FINAL ORDER

The Special Standards Request Form you submitted for owner: Joint Water Commission, Start Card number 201162, is hereby approved for the following: You may abandon the bottom of this well, from approximately 976 ft below ground surface (bgs) to above 933 ft bgs, as described on your Special Standards Request Form dated October 4, 2011. Your Special Standards Request Forms is enclosed. All other standards must be adhered to. This Special Standard was verbally approved on October 3, 2011.

Special Standards Request Form

- (7) Diagram showing the pertinent features of the proposed well design and construction:
(attach additional pages if needed)

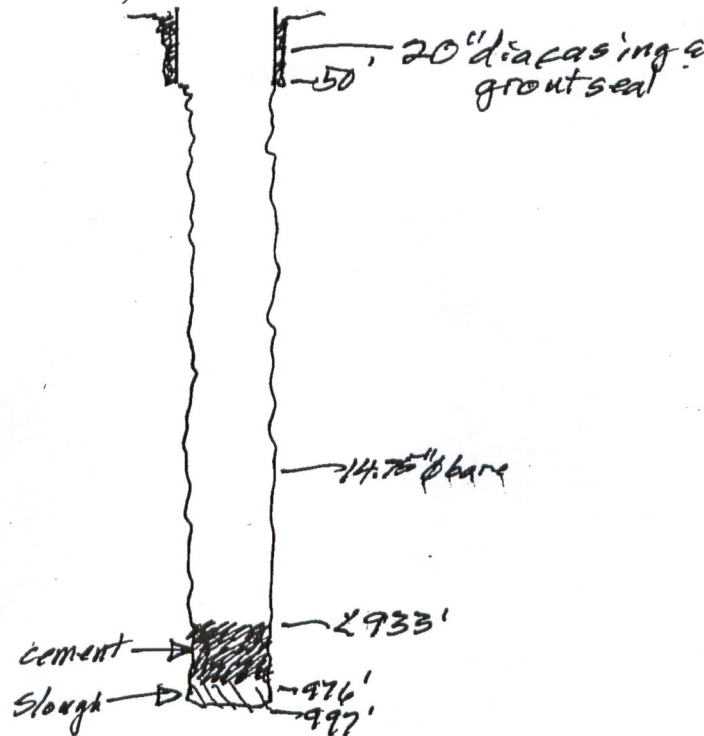
(5) The unusual site conditions which necessitate this request: Hole is for ASR. Drilled to 997'.
CRBG from 9' to 933'; sedimentary deposits (SD) from 933' to 997'. SD have caved more than once, currently
hole is at 976'. Want to decommission hole below the CRBG. Video shows no evidence of commingling from SD.

(6) The proposed construction methods that the bonded well constructor believes will be adequate for this well: (attach additional pages if needed)
Leave existing slough and pump neat cement grout from top of slough (~976') up to above 933'.
This will fill the voids from SD slough and provide a substantial plug to assure there can be no commingling from SD.
